SR 525

MUKILTEO FERRY TERMINAL (PHASE 2) FERRY TERMINAL CONSTRUCTION

VOLUME 1 SHEET INDEX

SHEET 69 OF 1521 SHEETS

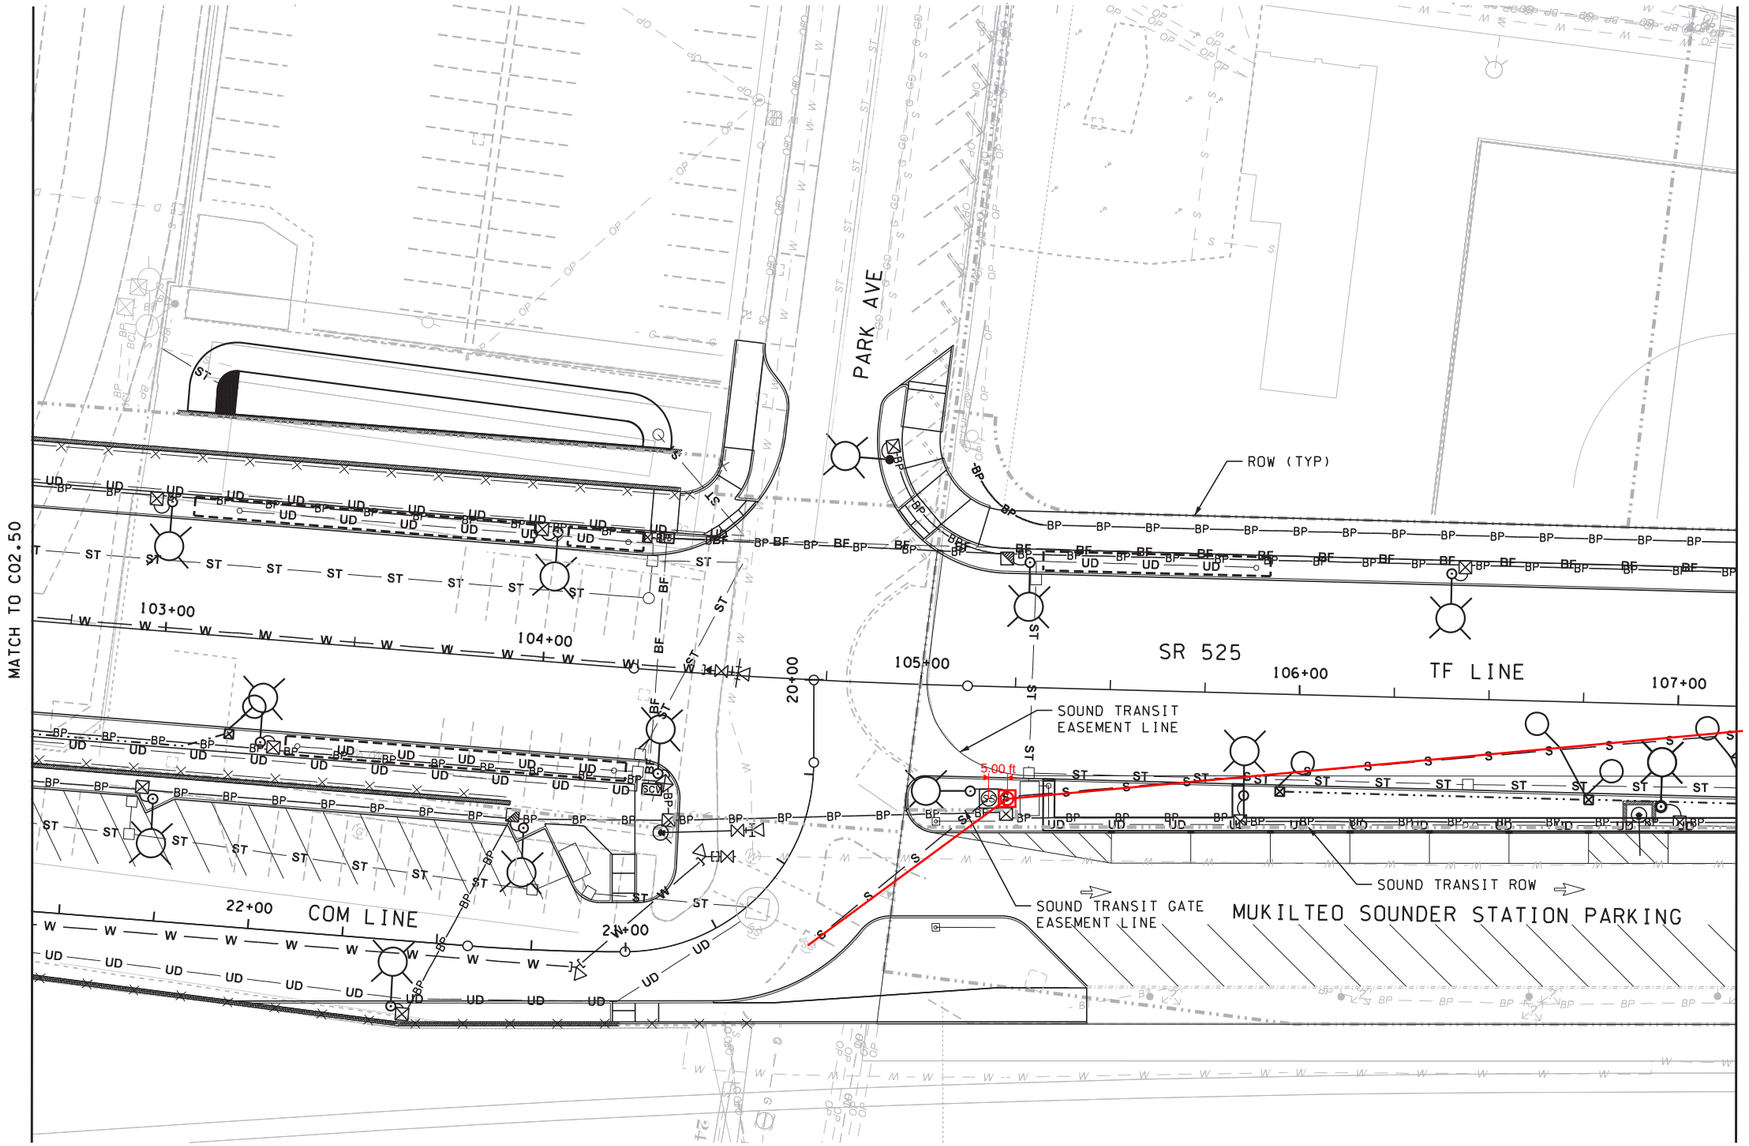
RFI 0237 -
Please verify the duct bank is actually 10 feet wide and the proposed luminaire pole #14 and gate are able to be installed in the proposed locations (see attached sheet C02.51). Sanitary sewer manhole can be relocated 5 feet further east. However, it should not impact installation of Modular Wetland MWS-2; the location of the j-box, just south of the manhole, will need to be adjusted to accommodate the new manhole location; and the buried power line going from the j-box to Luminaire pole #14 will need to routed around the western side of the new manhole.
Also, the easement to MWWD including the legal description and map/exhibit will need to be updated to show the easement centered on the installed sewer pipe location (7.5' on either side of the sewer pipe) going through the Sound Transit property (see attached sheet C08.11).

SHEET 69 OF 1521 SHEETS

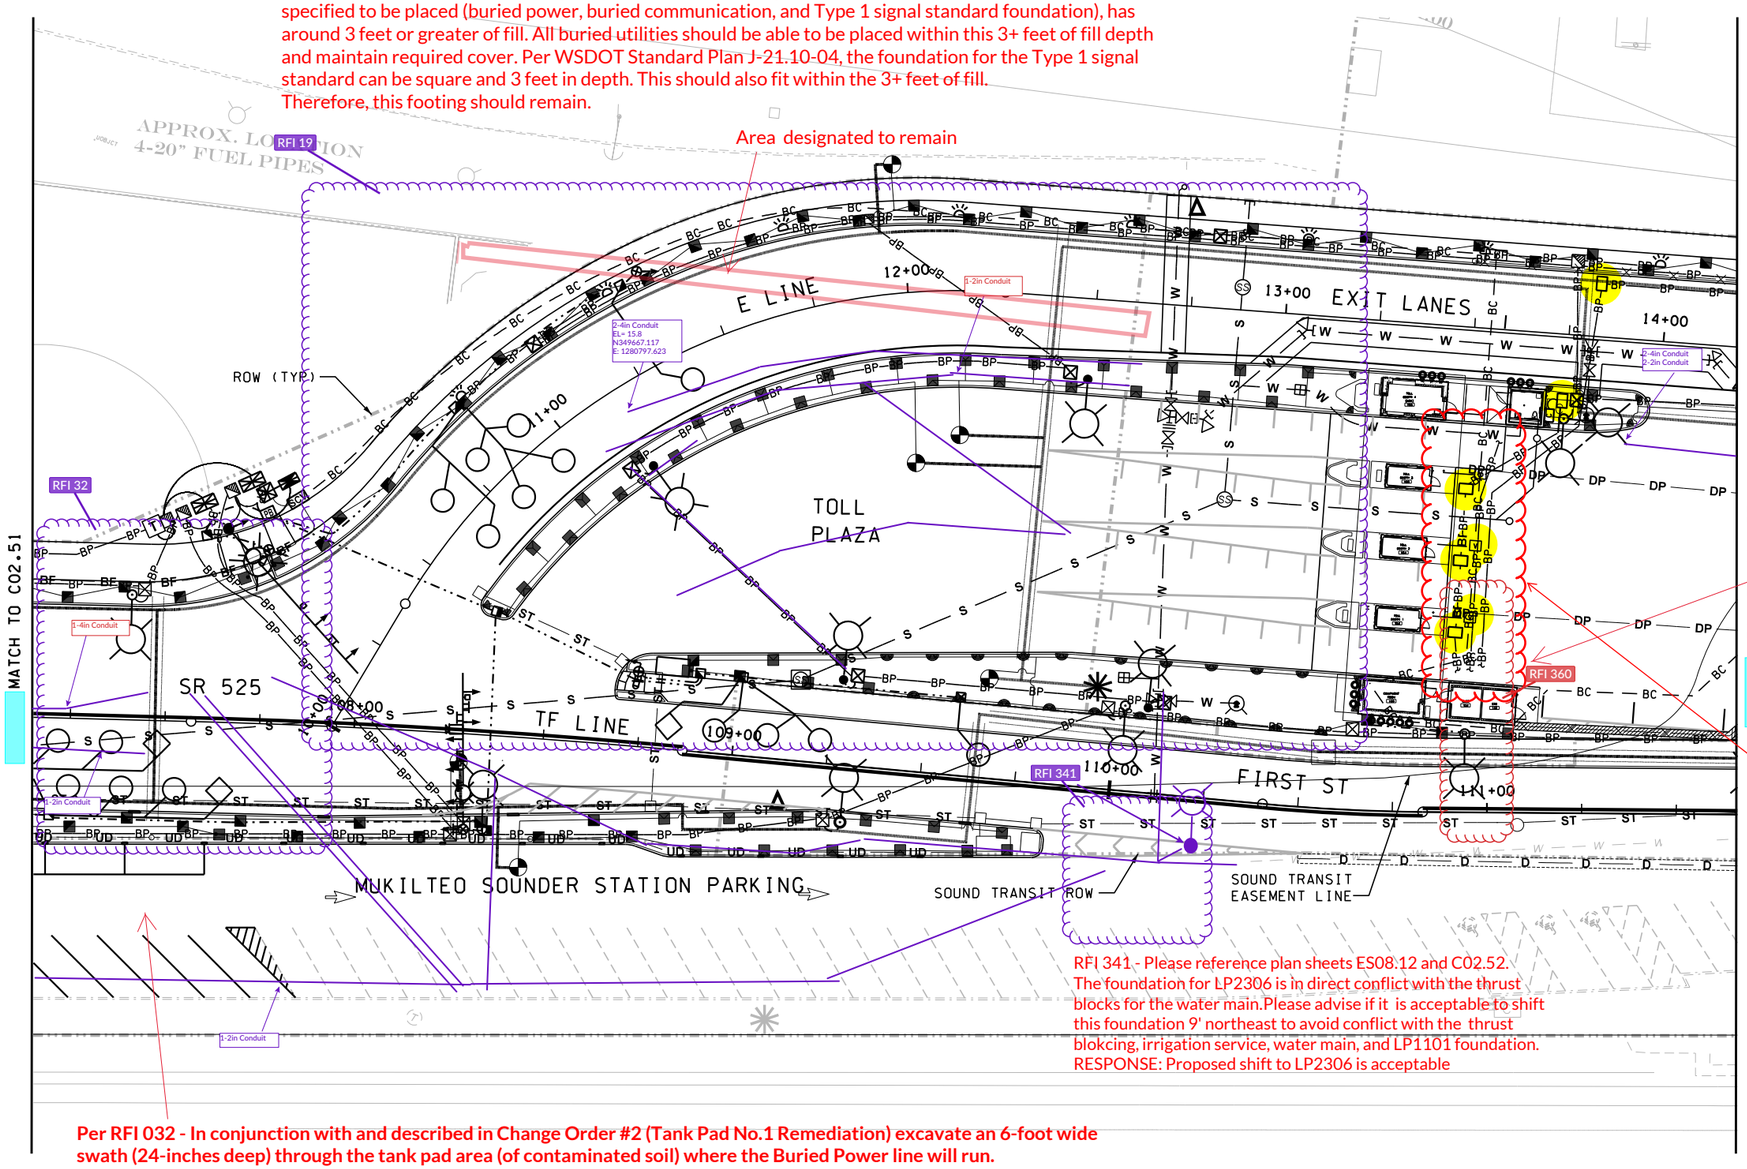
Per RFI 019 - The concrete slab and wall footing on the north side of Tank Pad #2 has been specified to remain to meet project commitments. In reviewing the plans, the wall footing and slab, in the areas where utilities are specified to be placed (buried power, buried communication, and Type 1 signal standard foundation), has around 3 feet or greater of fill. All buried utilities should be able to be placed within this 3+ feet of fill depth and maintain required cover. Per WSDOT Standard Plan J-21.10-04, the foundation for the Type 1 signal standard can be square and 3 feet in depth. This should also fit within the 3+ feet of fill. Therefore, this footing should remain.

RFI 341 - Please reference plan sheets ES08.12 and C02.52.
The foundation for LP2306 is in direct conflict with the thrust blocks for the water main.Please advise if it is acceptable to shift this foundation 9' northeast to avoid conflict with the thrust blokcing, irrigation service, water main, and LP1101 foundation.
RESPONSE: Proposed shift to LP2306 is acceptable

Per RFI 032 - In conjunction with and described in Change Order #2 (Tank Pad No.1 Remediation) excavate an 6-foot wide swath (24-inches deep) through the tank pad area (of contaminated soil) where the Buried Power line will run.
Backfill the trench area (and the removed contaminated soil) with CSBC.
At the location where the trench runs through the existing concrete collar - we request the collar be removed

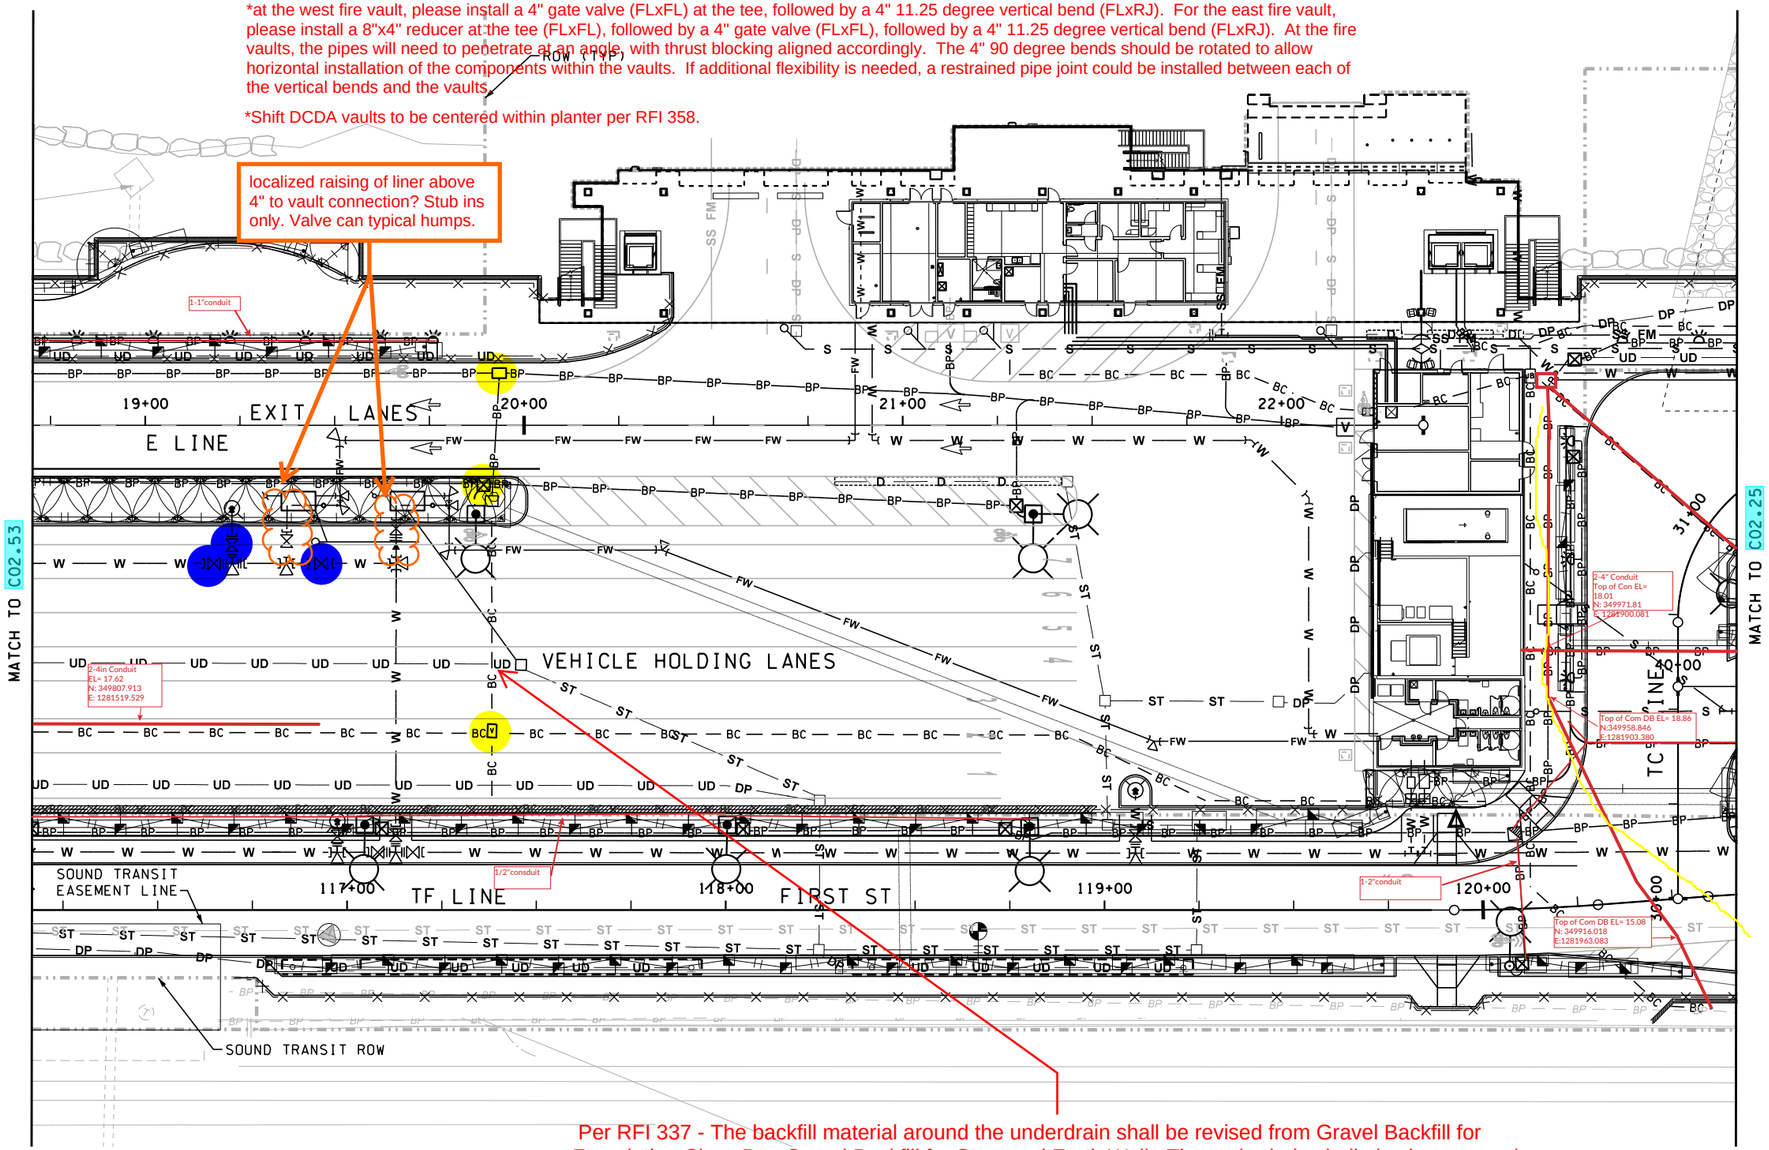
localized raising of liner above 4" to vault connection? Stub ins only. Valve can typical humps.

Per RFI 337 - The backfill material around the underdrain shall be revised from Gravel Backfill for Foundation Class B to Gravel Backfill for Structural Earth Wall. The underdrain shall also be wrapped with Construction Geotextile for Underground Drainage (see following revised plan sheet C07.49). A second underdrain pipe shall be installed at the downstream tie-in structure (C07.13-7 and C07.14-1) and extend 15' and capped. The second pipe is a redundant system in the event the main pipe becomes plugged with sediment. The second pipe shall be set at the same elevations as the main underdrain pipe and shall also be wrapped with Construction Geotextile for Underground Drainage.

SHEET 91 OF 1521 SHEETS

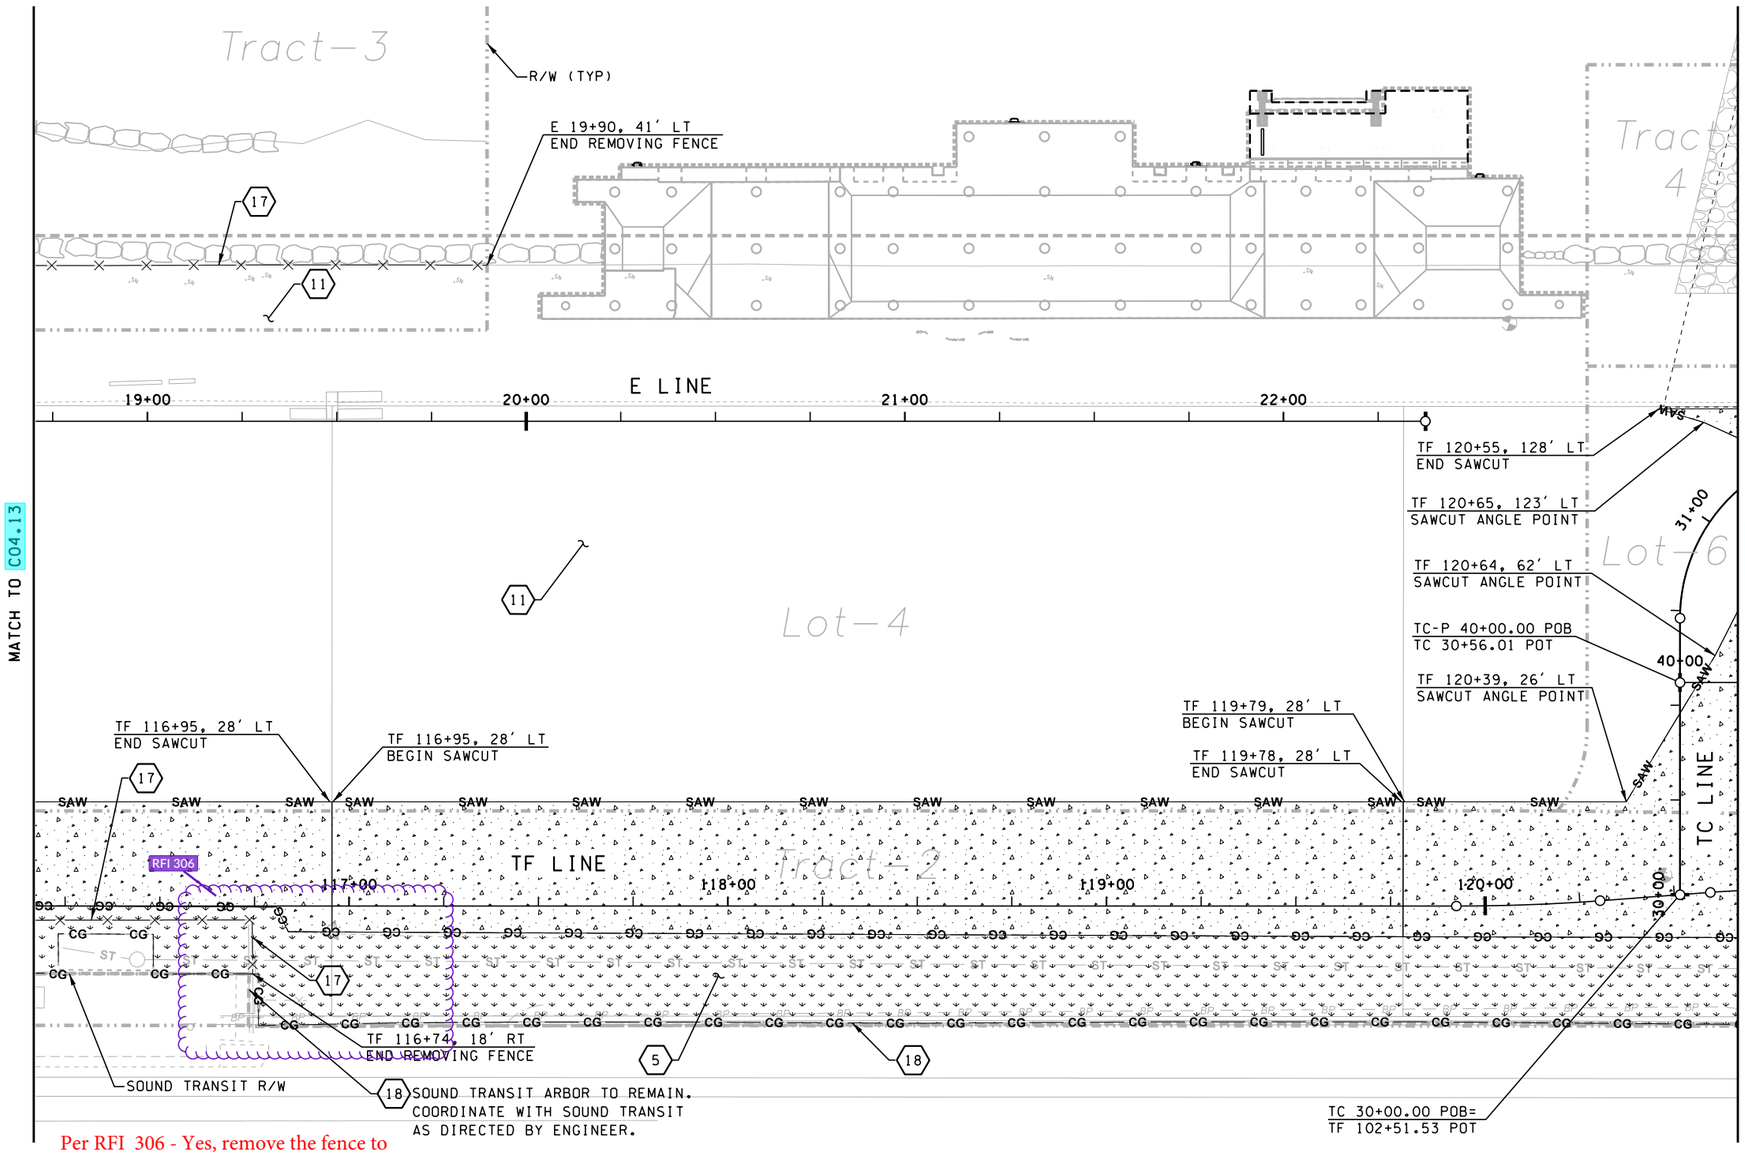
Per RFI 306 - Yes, remove the fence to the blue limits shown on this RFI and run the new fence from the existing post.

SHEET 92 OF 1521 SHEETS

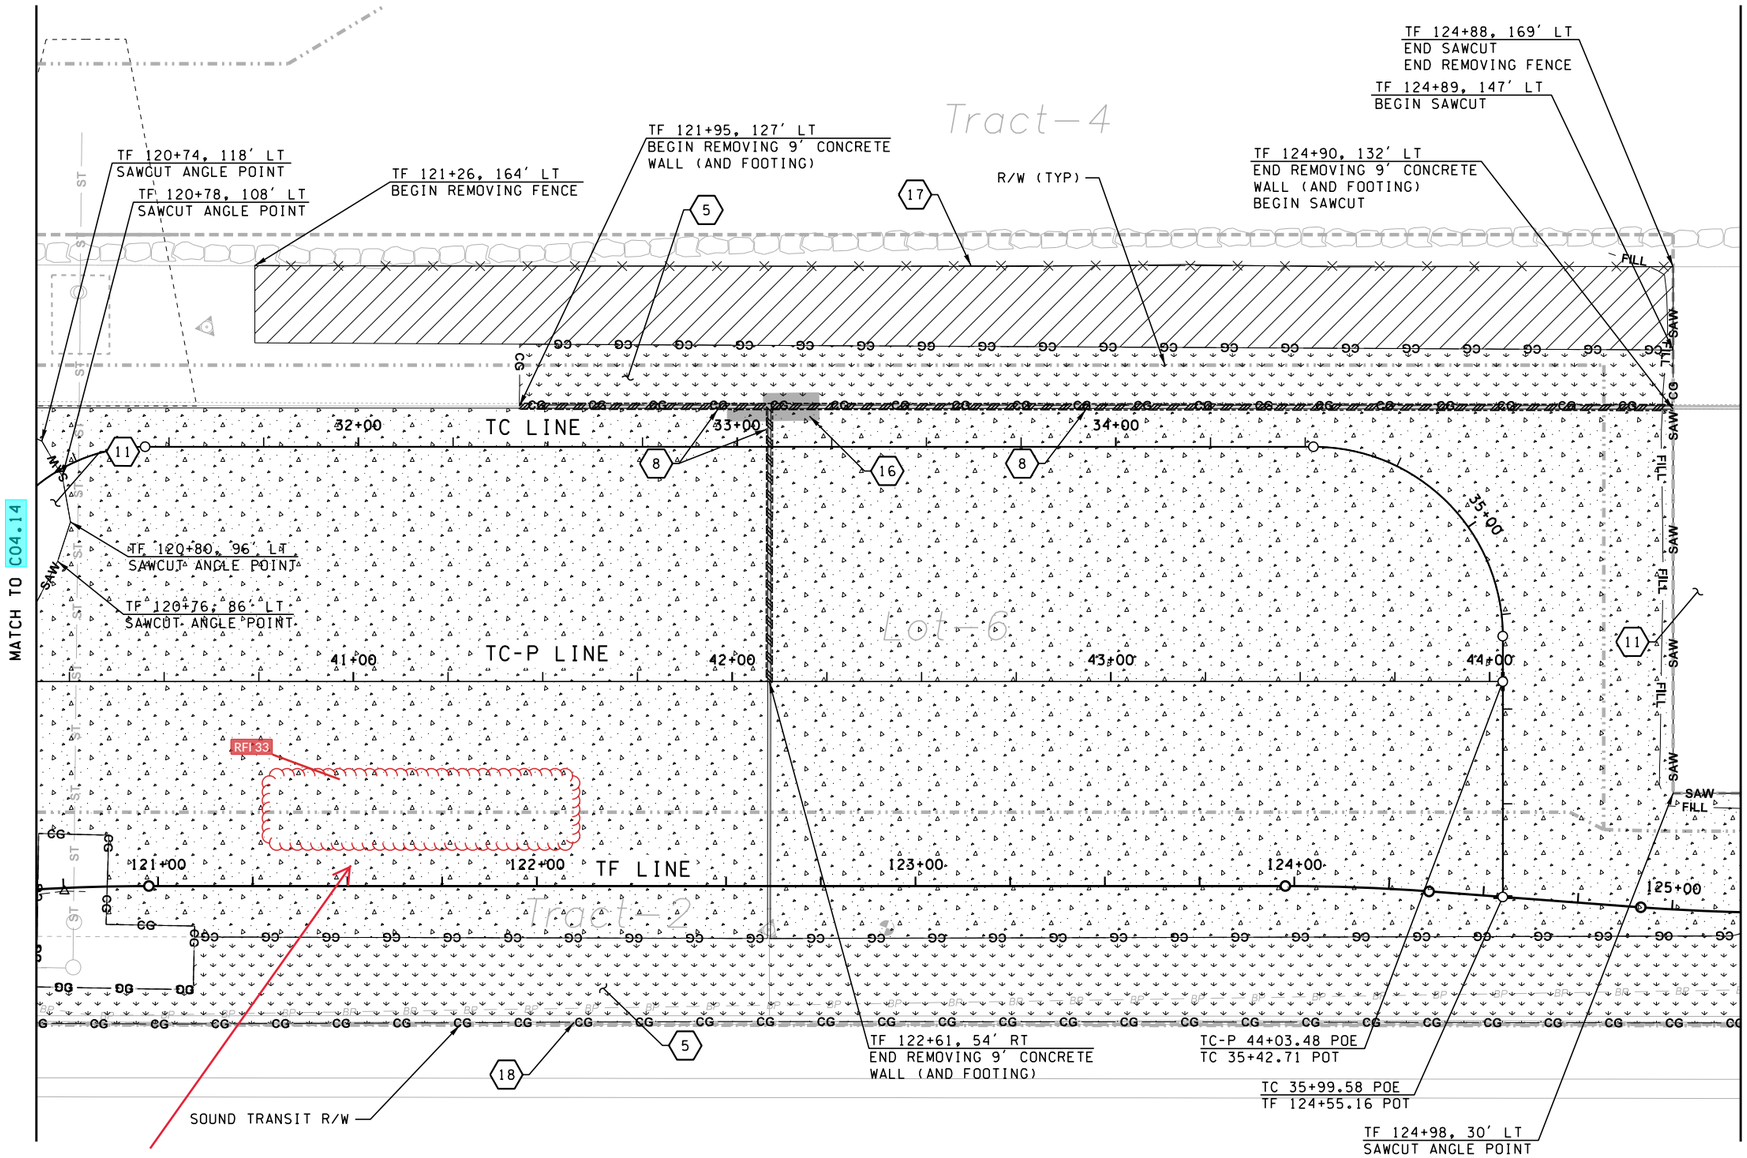
Per RFI 33 - Site Preparation plan C04.15 shows limits of concrete removal in the vicinity of the tank pads. The perimeter tank base stem walls shall be removed within the limits of concrete removal.
